**Subject** Amendment No. 6, Architectural Services Agreement - LCA Architects - Fremont High School New Construction Project – Division of Facilities Planning and Management

## AMENDMENT NO. 6

### ARCHITECTURAL SERVICES AGREEMENT

This Amendment is entered into between the Oakland Unified School District (OUSD) and LCA Architects. OUSD entered into an agreement with CONTRACTOR for services on **March 13, 2016** ("Agreement"), and the parties agree to amend the Agreement for the Services with **Fremont New Construction Project** as follows and in the attached Exhibit A:

### Bulletin Revision Issues

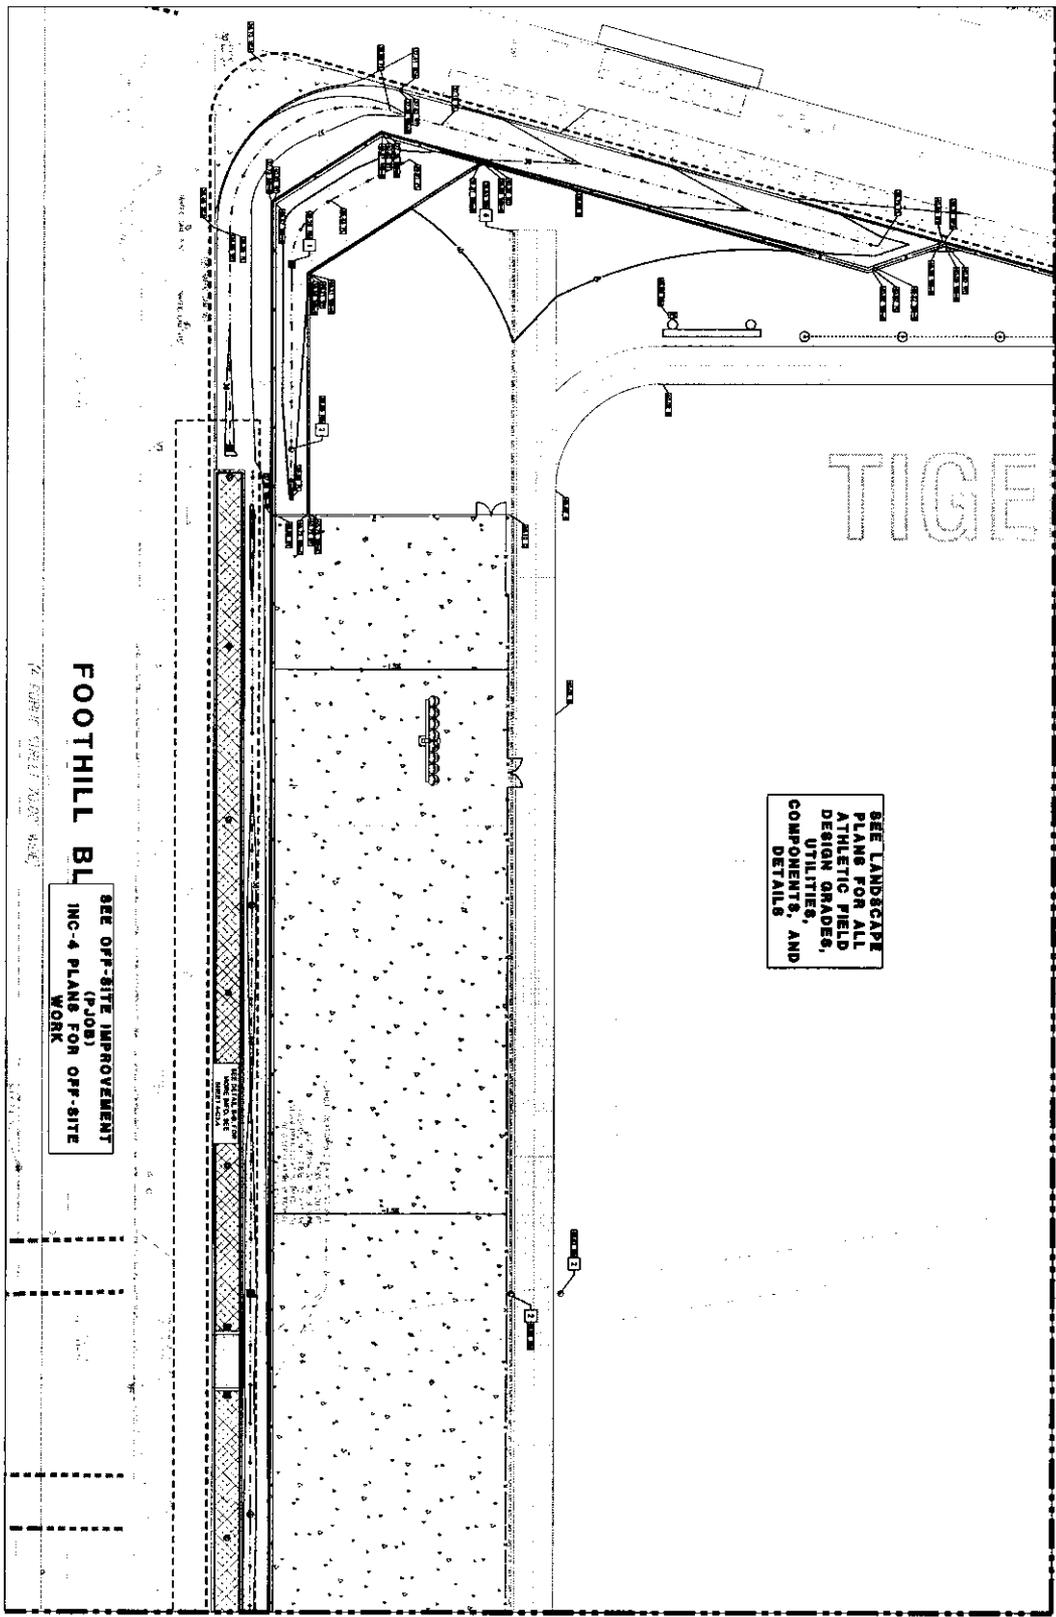
- Added is a leg of the INC1 SD to INC4 to pick up the Northwest corner RWL from the existing library.
  - It would be best if the line from the SD lift station at the bottom of the stairs was also connected to this leg.

- Updated is the table of varies gravity line utility crossings. See table on sheet C6.0.
  - Updated is the invert elevation of the 4" SD Line that Dylan Strangmeyer brought to our attention on Thursday 7/11.

- Holding the downstream invert of 36.71 and a slope of 1%, the correct IE at the building is 36.86.
- Revised Bulletin 4-004.4 responds to communication from CFJV that a portion of SD line was already installed per 4-004.2. Inverts and crossings adjusted per phone conversation between Cahill, Calichi & LCA.

- Revised Bulletin 4-004.3 responds to RFI's 4-064 & 4-073 as well as additional information observed and provide by contractor regarding existing conditions that differ from as-built and survey information used in design. SD, Gas, and SS lines have been coordinated around ductbank using info. provided by CFJV. Electrical utilities have been coordinated with needs for MPoE in Bldg B.

- Revised Bulletin 4-004.2 responds to email from contractor to revise invert elevations between POC at building and main tie-ins. Domestic water supply pipe size was also revised in coordination with plumbing requirements.

- Revised bulletin 4-004.1 adds two plumbing sheets (4-P2.01 and 4-P2.02) documenting revisions in response to RFI 4-037.1 and RFI 4-044 related to furring behind urinals and piping outside of walls.
- This bulletin provides revised civil utility plans and underground plumbing plans in response to the following RFI's: 4-039 Plumbing Stub Outs, 4-040 FSR Location (see also CCD 4-003 pending DSA Approval), 4-045 Storm Drain, 4-049 Conc Duct & SD, 4-050 Utility Pole & SD.

- Grading and Drainage Sheets: 4-C3.0, 4-C3.1, 4-C3.2, 4-C3.3, 4-C3.4

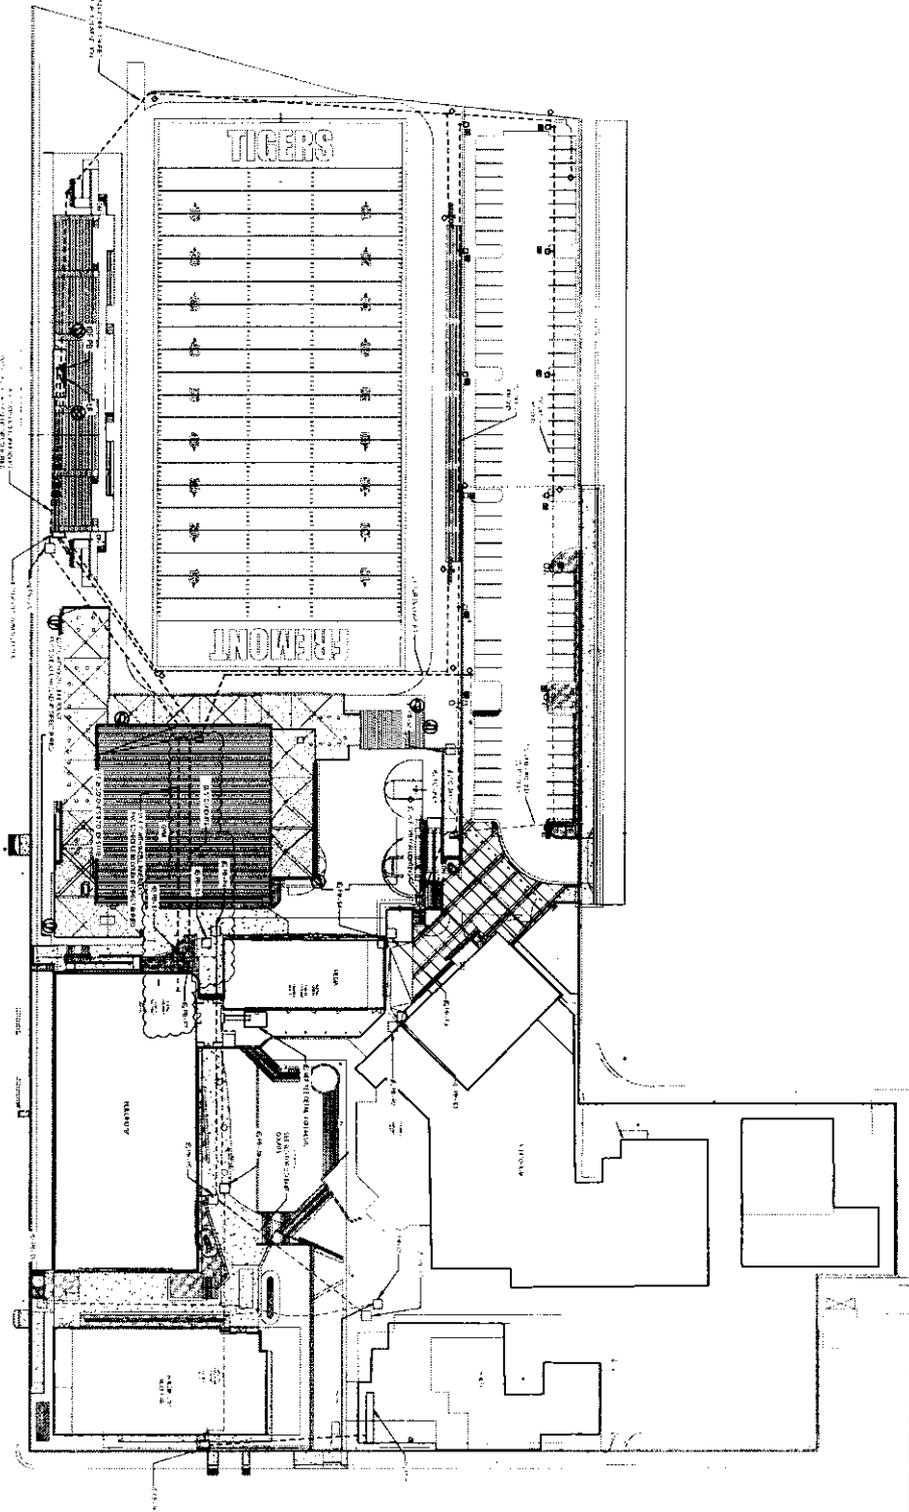
Summary: **This bulletin provides revised grading plans, in coordination with storm drain design issued as part of Bulletin 4-004.3.**

- Sheets 3-A2.01, 3-A2.02

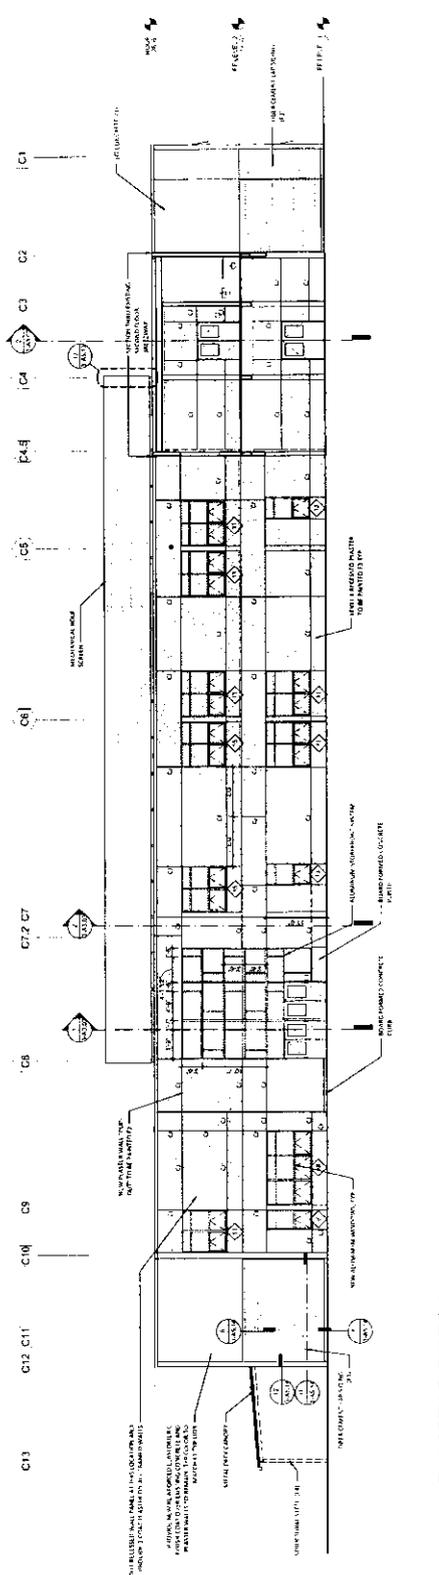
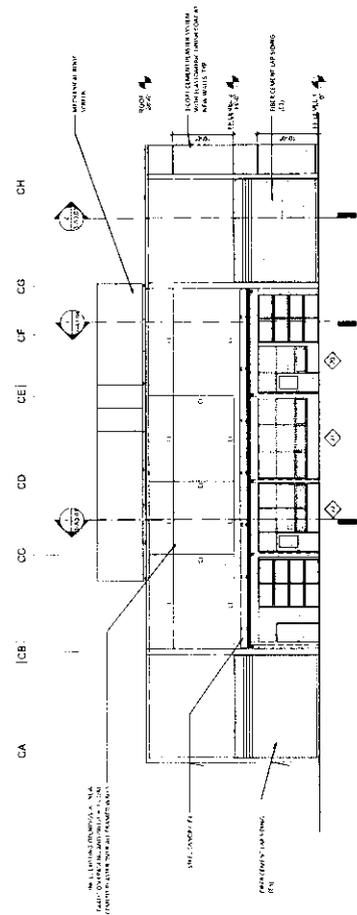
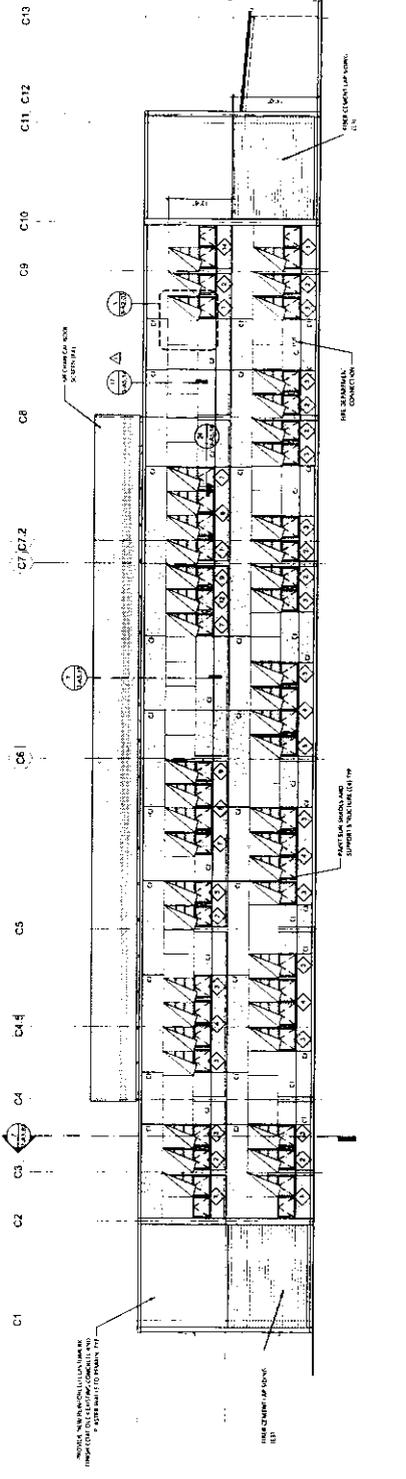
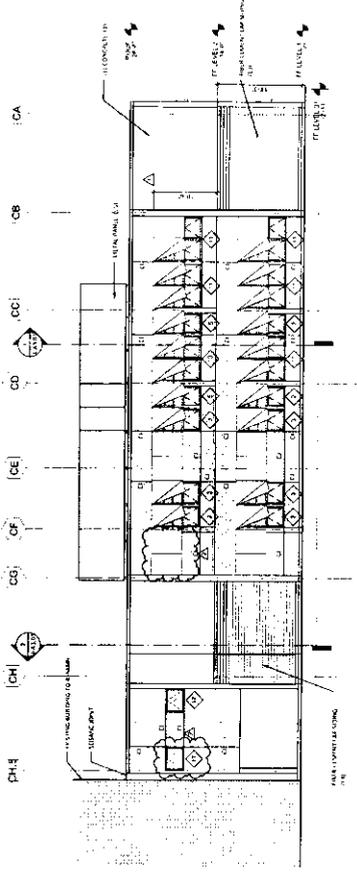
**3-006.1 adds Sheet 3-A2.01 and identifies control joints on both elevation sheets. The other sheets are unchanged.**
